ADDENDUM NO. 3

Reference: Demolish City Pool & Create Intramural Ball Fields
Southern Utah University – Cedar City, Utah
Project No.10058730

**ADDENDUM NO. 2
TO
CONTRACT DOCUMENTS
FOR
SUU INTRAMURAL SOCCER FIELDS**

GENERAL NOTES

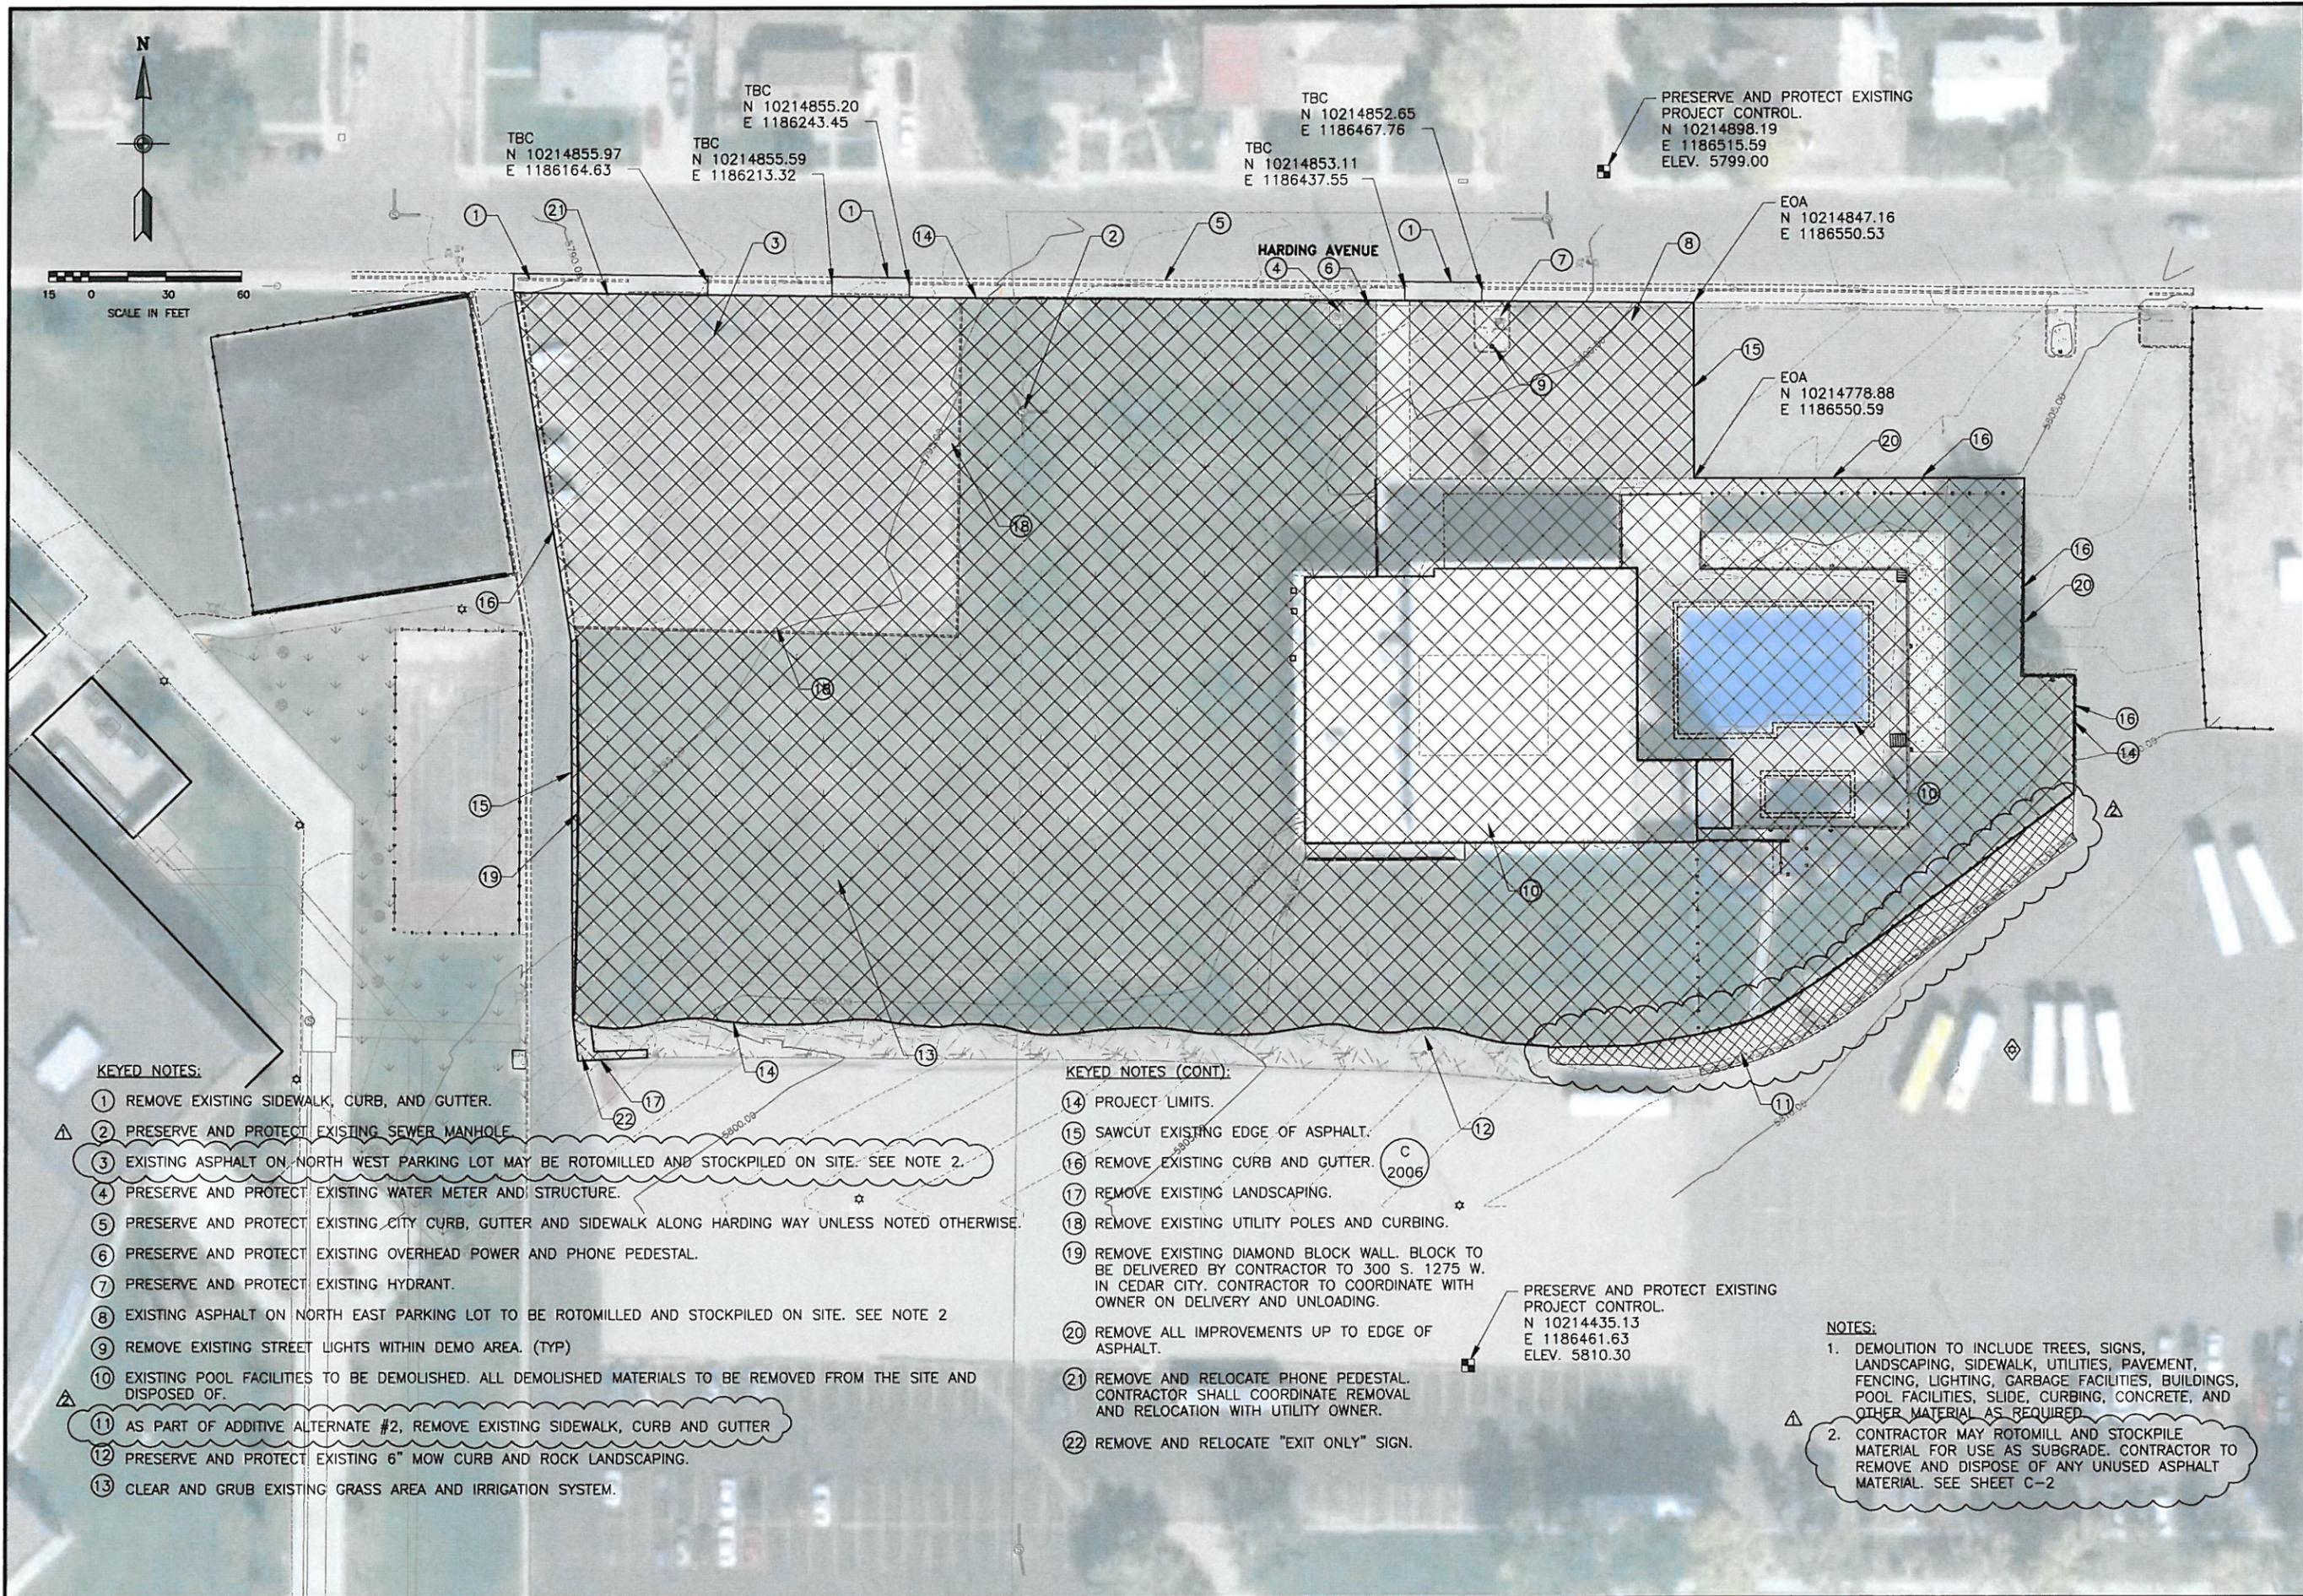
26. ADDITIVE ALTERNATE #2 IS FOR THE ADDITIONAL COST REQUIRED TO PROVIDE AND INSTALL 3" OF ASPHALT OVER 8" OF BASE COURSE ON THE PROPOSED GRAVEL PARKING LOT. IT ALSO INCLUDES DEMOLITION OF SIDEWALK AND LANDSCAPING.

NO.	DATE	REV. BY	DESCRIPTION
1	8/17/10	J.A.	NOTE CHANGE

DRAWING NO.
C-1
SHEET 5 OF 14

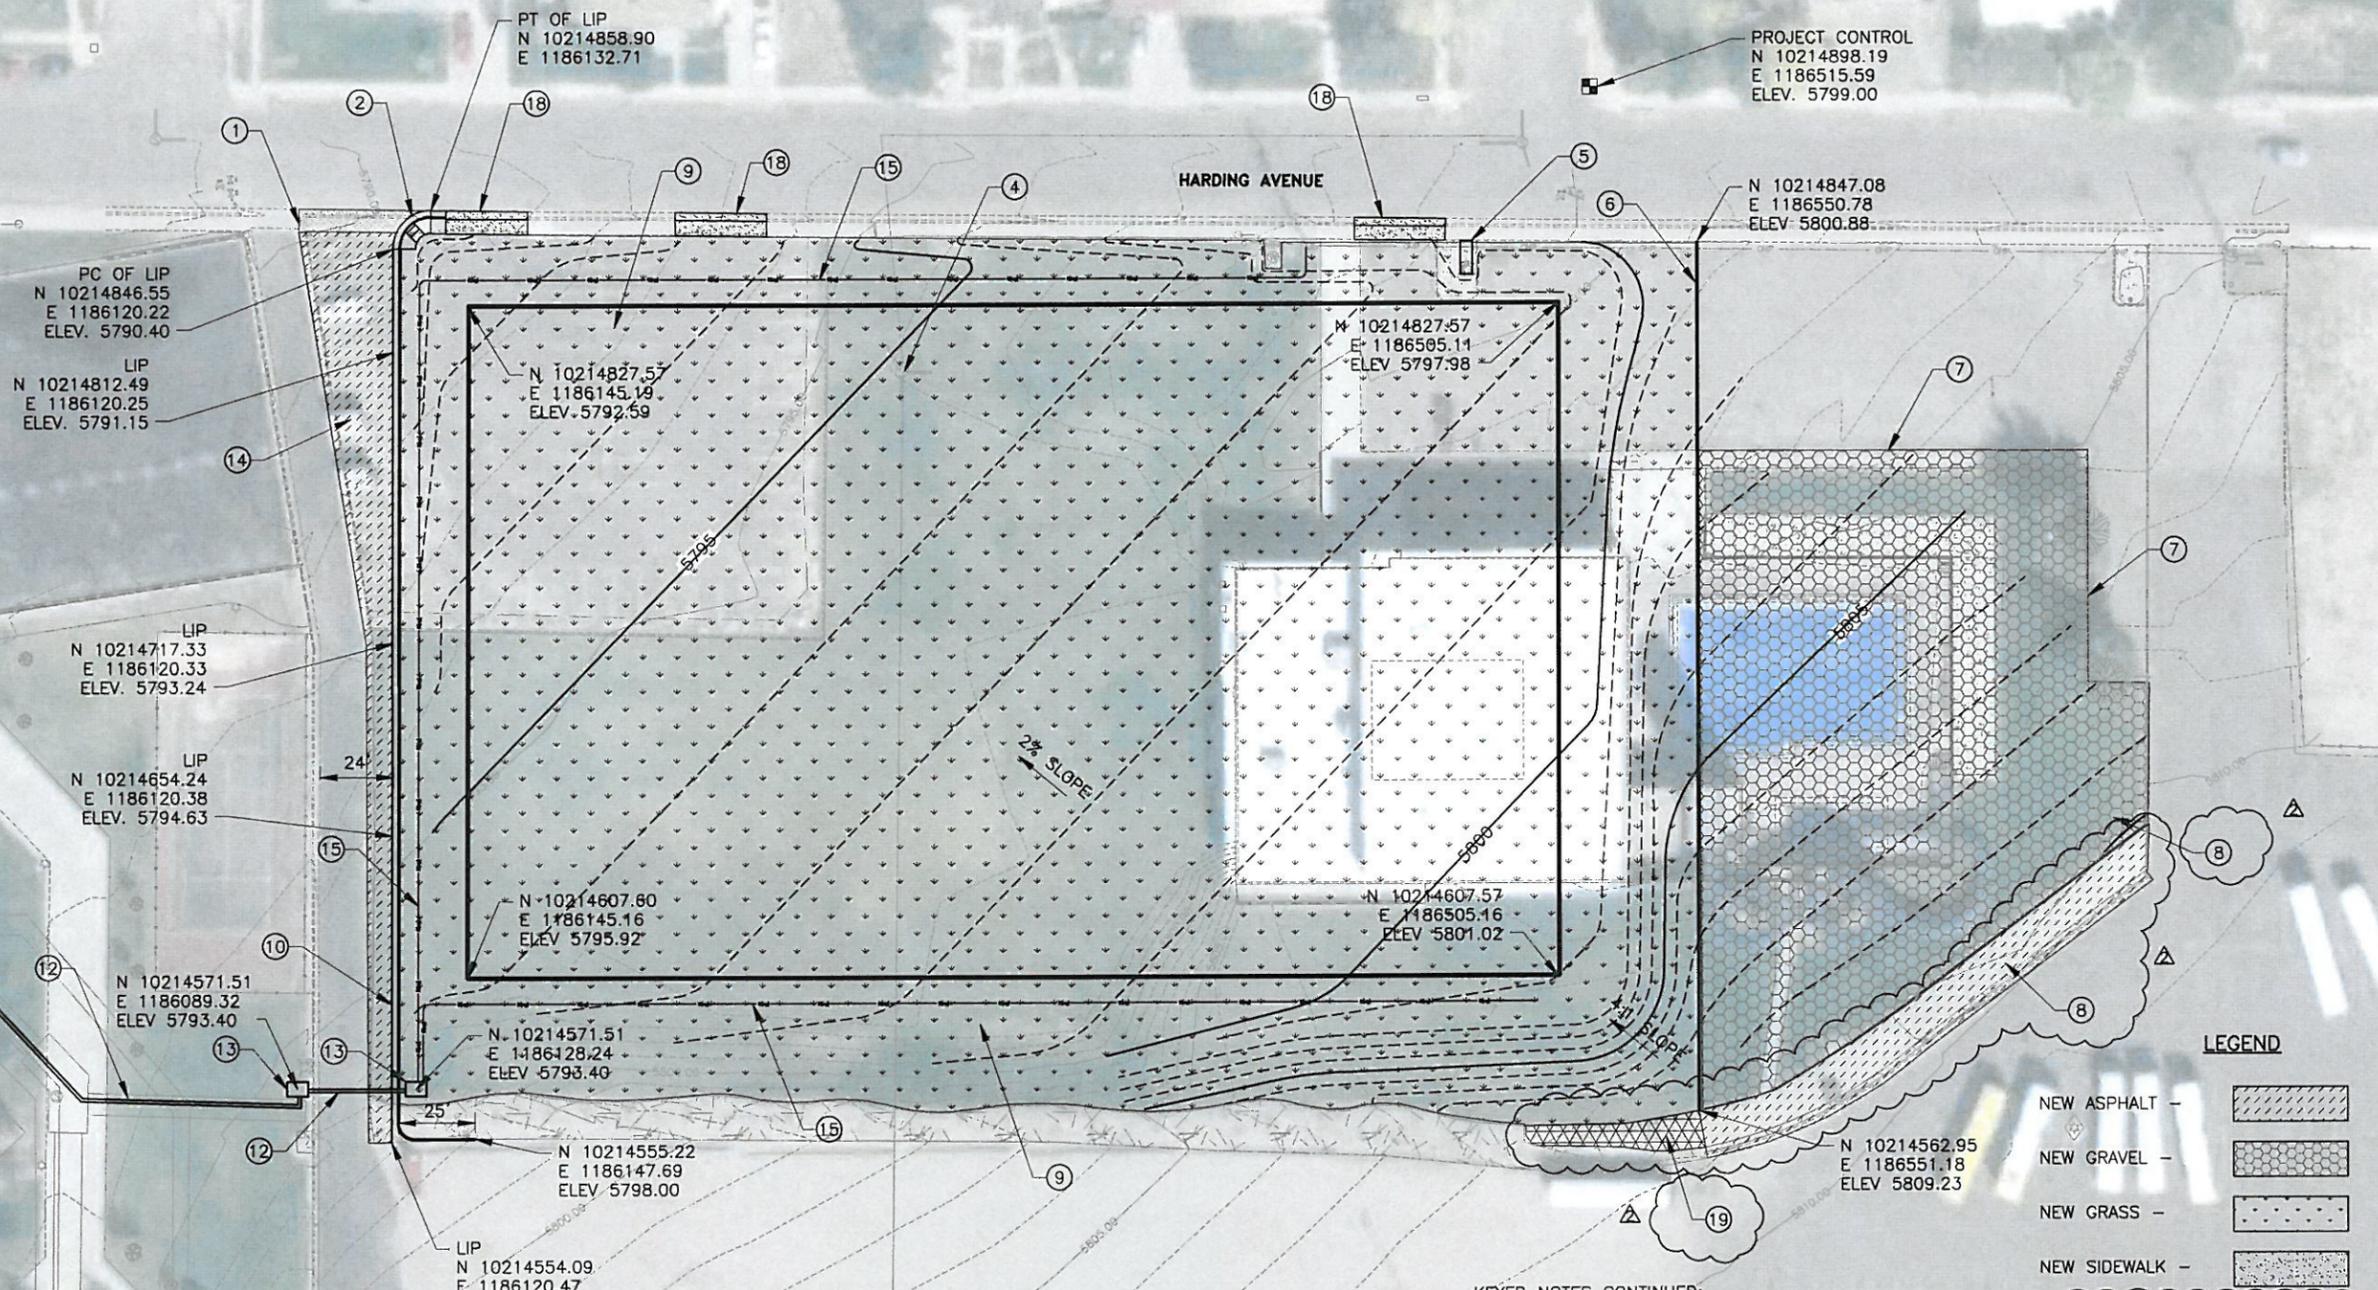
- Demolition of existing sidewalk, curb and gutter, including saw-cutting of pavement, as shown on the attached Drawing C-1.
- Installation of landscaping to match surrounding landscaping and the installation of an additional 75 feet of 6" mow curb as shown on the attached Drawing C-2. Contractor shall tie new irrigation drip system into existing drip system.
- Installation of 3" of asphalt instead of gravel on the proposed parking lot shown on the attached Drawing C-2. Total square footage of the proposed parking lot will be increased to approximately 28,000 square feet.

- ⚠ ⑪ AS PART OF ADDITIVE ALTERNATE #2, REMOVE EXISTING SIDEWALK, CURB AND GUTTER
- ⑫ PRESERVE AND PROTECT EXISTING 6" MOW CURB AND ROCK LANDSCAPING.
- ⑬ CLEAR AND GRUB EXISTING GRASS AREA AND IRRIGATION SYSTEM.
